Our Ref: 3034-01/LK2

PROPOSED CHRISTMAS FARM, LAND TO THE SOUTH OF LLAY ROAD, CEFN-Y-BEDD, WREXHAM

PLANNING APPLICATION REFERENCE P/2022/0681

ENCLOSURE 2 – AXIS FORWARD VISIBILITY SITE VISIT CHECK PHOTOS - 17TH JULY 2023

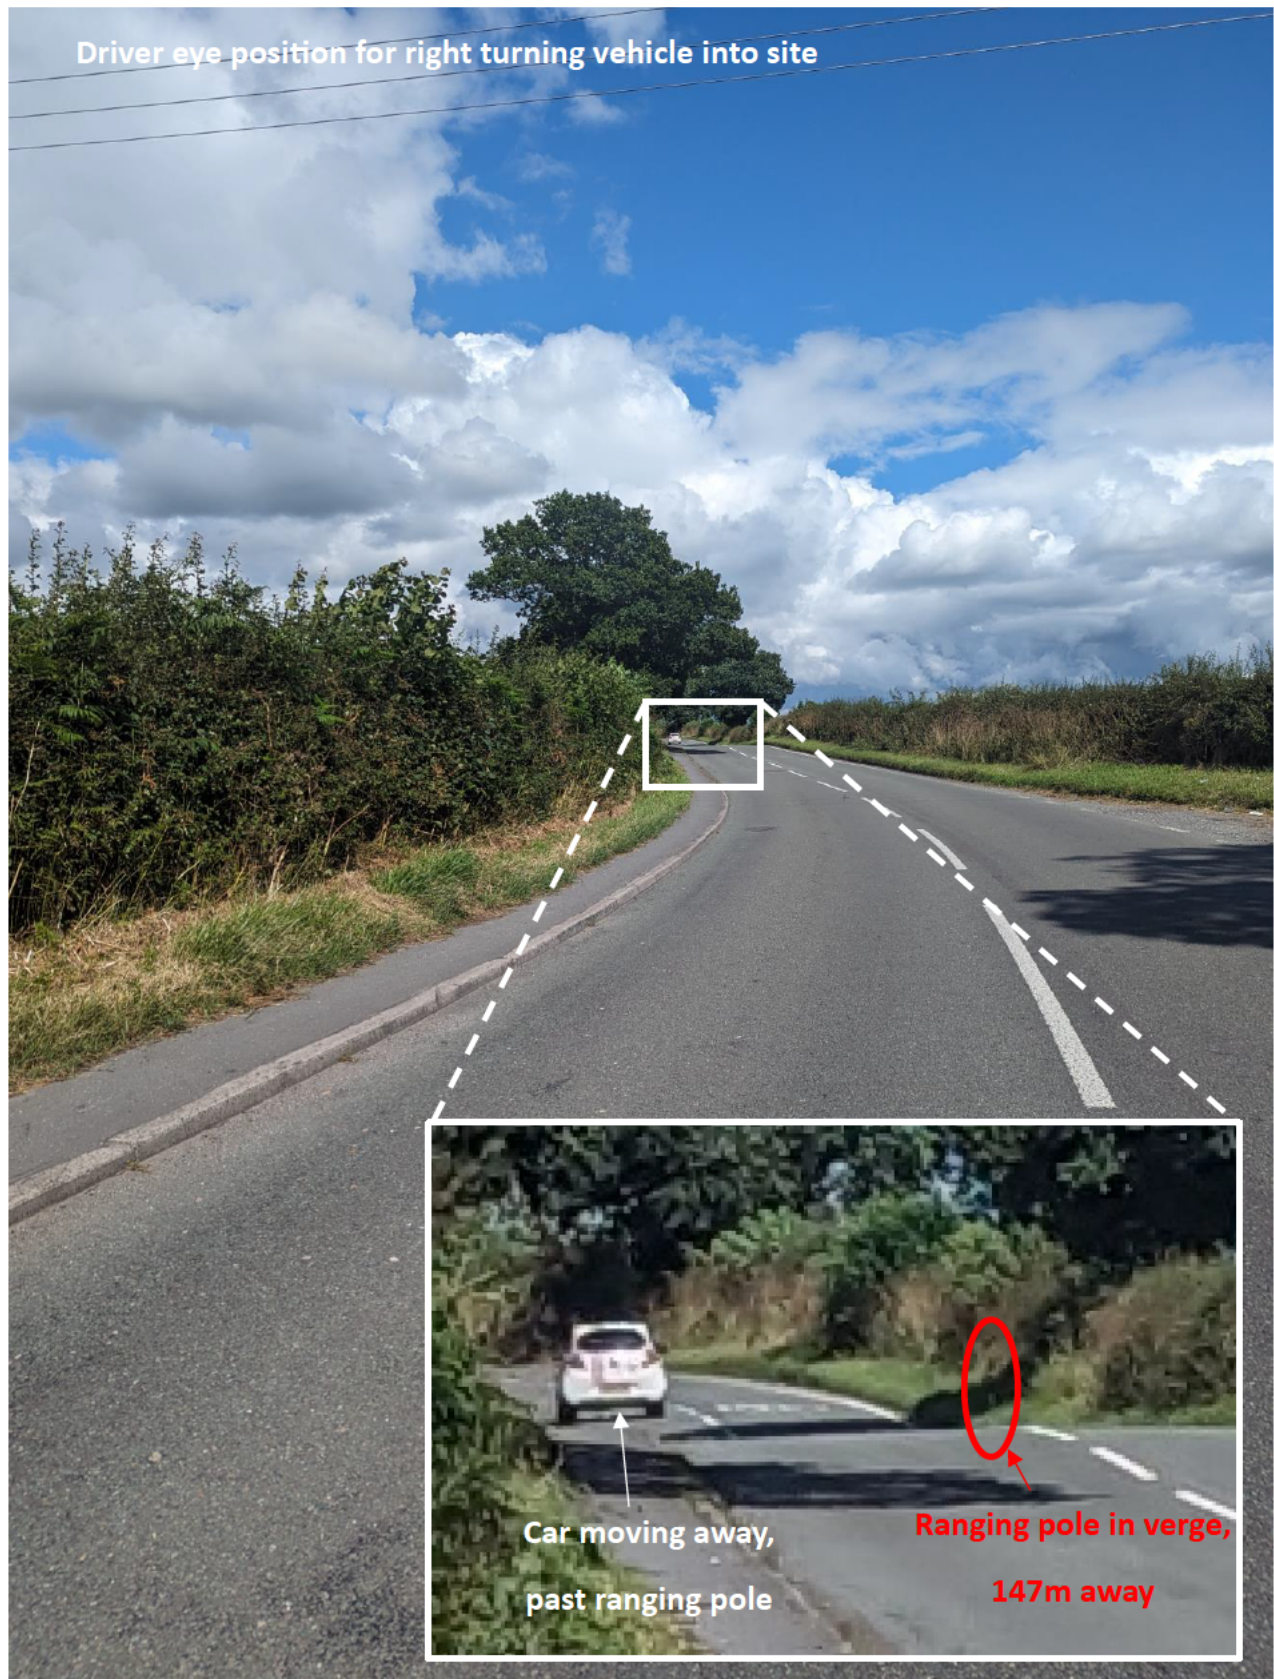
"However, the forward visibility splay shown on the drawing for 147m between a vehicle waiting to turn right into the site and a vehicle approaching the site from the east, is not achieved due to the existing hedgerow located on the northern extents of Llay Road obstructing the splay.

It is noted from the applicants March response (ref: 3034-01/JW) that they disagree with this assessment (regarding the hedgerow). Highways do not agree with the applicant's justification and as previously noted, to achieve the required SSD visibility, the vegetation located on the northern side of Llay Road, within the extents of the visibility splay, will need to be cleared. It is noted that the hedgerow on the northern extents of Llay Road is not within the applicant's current ownership.

The development site access as it is currently proposed cannot be approved, since inadequate visibility splays is a highway safety concern."

Notwithstanding this, and to corroborate the plan-based exercise contained in Axis' letter dated 3rd March 2023 with further evidence, I visited the site yesterday (17th July 2023) to carry out a physical survey of the ability for vehicles waiting to turn right into the site to see oncoming westbound traffic, and vice versa.

To do this, I identified the point where a right turning vehicle would be positioned when waiting to turn into the access, and then measured a distance 147m away along Llay Road in an easterly direction. I then placed a ranging pole safely within the verge at a point 147m from the vehicle waiting position and returned to the right-turning vehicle waiting position.

When the road was clear of any approaching traffic I was able to walk out to the vehicle waiting position and easily observe the ranging pole 147m away, and furthermore, the full extent of the carriageway (both sides) alongside it. I was also able to observe the position of a right turning vehicle in the opposite direction, i.e. from the position of the ranging pole some 147m away.

In other words, the on-site survey exercise demonstrated that a 147m forward visibility splay between a right turning vehicle and westbound approaching traffic is easily achievable.

The exercise demonstrated that forward visibility splays of around 5-10m longer than the requirement are actually achievable, and therefore that the OS-mapping underpinning Axis' drawing number 3034-01-D02B presents a slightly more conservative picture of what level of forward visibility is achievable compared to the real-world position.
